COUNCIL ASSESSMENT REPORT

Panel Reference	2018ECI005
DA Number	DA-2018/1187
LGA	Bayside Council
Proposed Development	Integrated Development - Construction of a fourteen (14) storey mixed use development including 305 residential units, commercial tenancies, a child care centre (74 places) and basement car parking for 440 cars (including 90 public car parking spaces) and public and private landscaping works
Street Address	256 Coward Street, Mascot
Applicant/Owner	Applicant: Karimbla Constructions Services (NSW) Pty Ltd Owner: Karimbla Constructions Services (NSW) Pty Ltd
Date of DA lodgement	9 October 2018
Number of Submissions	Nil
Recommendation	Approval, subject to conditions.
Regional Development Criteria (Schedule 7 of the SEPP (State and Regional Development) 2011)	Development with a Capital Investment Value of over \$30,000,000 (Nominated CIV: \$94, 906,102)
List of all relevant s4.15(1)(a) matters	<ul style="list-style-type: none"> • State Environmental Planning Policy (BASIX) 2004 • State Environmental Planning Policy (Infrastructure) 2007 • State Environmental Planning Policy (Vegetation in Non-Rural Areas) 2017 • State Environmental Planning Policy (Educational Establishm

Figure 13: Extract from Level 3-4 plan highlighting the design element (redacted)

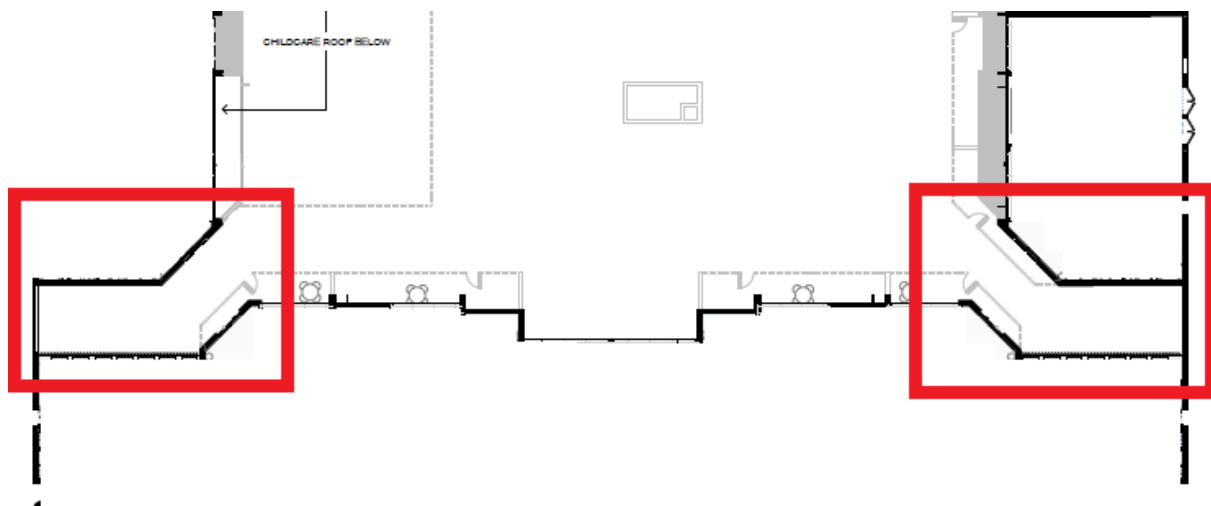
The proposal does not meet the ADG minimum building separation distances in the “corner units” (a total of 44 from the proposed 305), with the separation distances ranging from 3.7m to 4m, as shown below:

Comment: The screening has been placed on the southern elevation of the northern units as it will receive no natural light in mid-winter whilst no screening has been placed on the southern units as the relevant openings are north facing, which will not compromise these units to any access to light and air. It also strikes an appropriate balance with the outlook and views from habitable rooms and private open space for the southern units, as demonstrated in the figure above.

Figure 14: Extract from Clause 4.6 statement

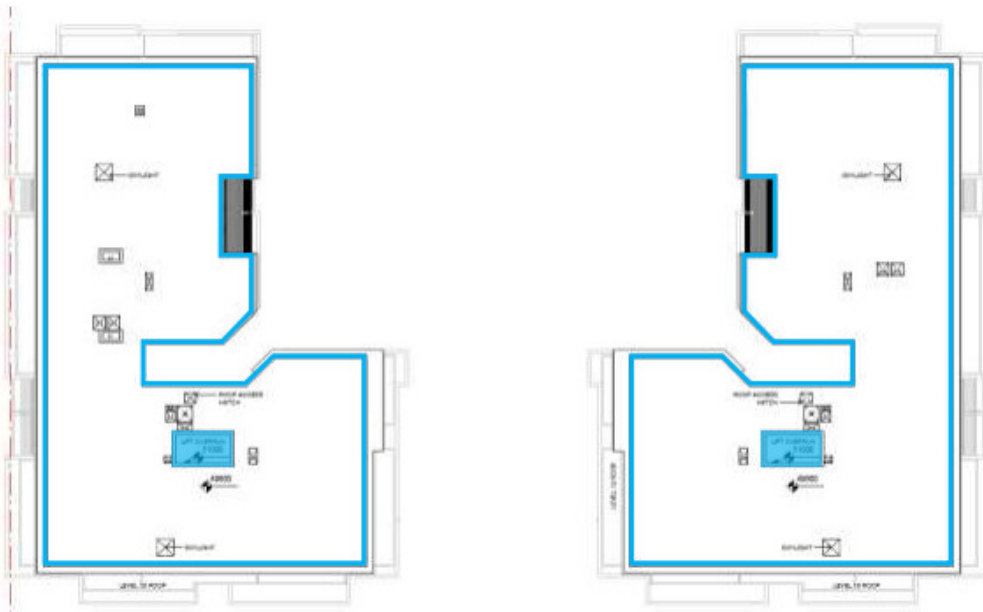
The proposal seeks maximum building height of 45m, which exceeds the 44m standard and represents a variation of 2.3%.

The proposed roof parapet seeks a 0.3 metre variation; and the proposed plantrooms seek a 1.0 metre variation. These components of the development occupy only a small proportion of the overall area of the development, as shown in the figure below:

Figure 15: Typical front setback on upper levels (extract from Level 3-4 plan (redacted))

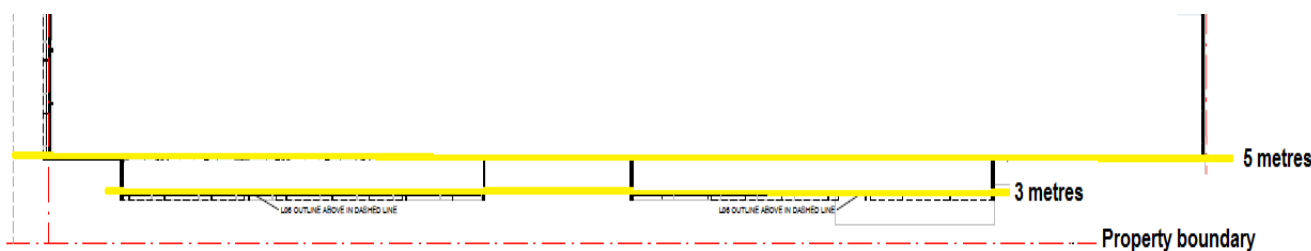
A maximum of six units out of the ten units that have a frontage to Coward Street encroach the 5 metres, with a large portion of these units containing private open space with relation to winter gardens.

As evidenced in the diagrams below, the extent of the non-compliance in fact decreases as the floor number increases.

With the above considered, it is recommended that this variation is supported by the Sydney Eastern City Planning Panel.
